<b>Office Action Summary</b>	<b>Application No.</b> 10/598,232	<b>Applicant(s)</b> WLODARCZYK, ANTHONY	
	<b>Examiner</b> RYAN A. VARNUM	<b>Art Unit</b> 3751

### **DETAILED ACTION**

## **Annotated Fig. 2**

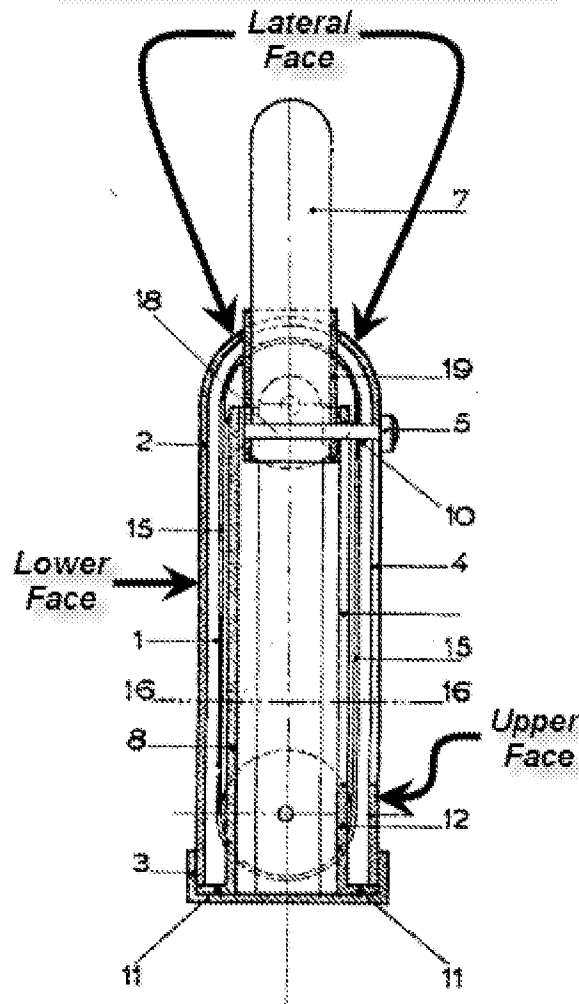
7. In re Claims 11, 12 and 22, Pecq discloses a device capable of being used as a writing implement comprising: a body 2 (Fig. 1) having an opening (See Fig.'s 1 and 2, the opening sealed by surface 1 in Fig. 1 and penetrated by writing tip 7 in Fig. 2) through which a writing tip 7 (“make up stick”; Fig. 2; Para 2, Line 4) passes along a longitudinal direction (See Fig. 2), and a slot 4 (Fig.'s 1-2) extending approximately along the longitudinal direction (Fig.'s 1-2); a support 19 (“tube carry make up”; Fig. 2; Para 2, Line 3) on which the writing tip is mounted (See Fig. 2), said support being

placed inside said body (See Fig. 2); a strip 1 ("foil"; Fig.'s 1, 2 and 5; Para 7, Line 1) comprising a first portion fixed to said support (See Fig. 2; it being seen that the strip 1 is fixed to support 19 by way of stud 18; Para 2, Lines 1-4), a central portion and an end portion guided along a curved path (See Fig.'s 2, 3 and 5; it being seen that the strip 1 has an end and a central portion; and the curved path being defined by the space between rollers 6 and the body 2), said strip being flexible (Para 7, Line 1 to Para 10, Line 2) and capable of being moved between two positions (See Fig.'s 1-2), namely a writing position in which said strip gives access to the opening (See Fig. 2) and a stowing position in which said strip closes off the opening (See Fig. 1); and a button 5 (Fig.'s 1-2) connected to said support (See Fig. 2), said button being capable of being moved along the slot between a distal position relative to the opening, for which said support and said strip are in the stowing position (See Fig. 1), and a proximal position relative to the opening, for which said support and said strip are in the writing position (See Fig. 2); wherein said body includes a lower face and an upper face connected together by at least one lateral face having a small height so as to produce a writing implement having a substantially flat shape (See Annotated Fig. 2 below), and wherein the slot 4 (Fig.'s 1-2) is made in the upper face (See Annotated Fig. 2 below), and the opening is made in the lateral face (See Annotated Fig. 2 below) along which the end portion of said strip moves between the writing position and the stowing position (See Fig.'s 1-2); the end portion of said strip possesses an oblong window 15 (See Fig. 5) which, in the writing position, is positioned so as to face the opening for the passage of the writing tip (See Fig. 2).

8. In re Claims 13-15 and 17-19, Pecq further discloses said button 5 (Fig.'s 1-2) is connected to said support 19 (Fig. 2) by a lug 18 ("stem"; Fig. 2) passing through the slot 4 (Fig. 2), the lug being fixed by a tongue 18 ("stem"; Fig. 2) perpendicular to the first portion of said strip (See Fig. 2; it being seen that the stem 18 serves the function of both a lug for holding the button and a tongue for fixing the button to the strip); wherein

the lug, the tongue and said strip comprise a unitary member (See Fig. 2, it being seen that the three structures are assembled in engagement with one another); the upper and lower faces are substantially oval (See Fig. 1 and Annotated Fig. 2 above; it being seen that the faces of the device are substantially oval in the sense that they each have an oval end); said support butts against the internal wall 8 (Fig. 2) of said body during its displacement in the writing position (Para 3, Lines 2-3; "tube carry-make-up 19 in slides 8 in form"; it being understood that support 19 abuts the internal wall 8 as it slides along it to the writing position).
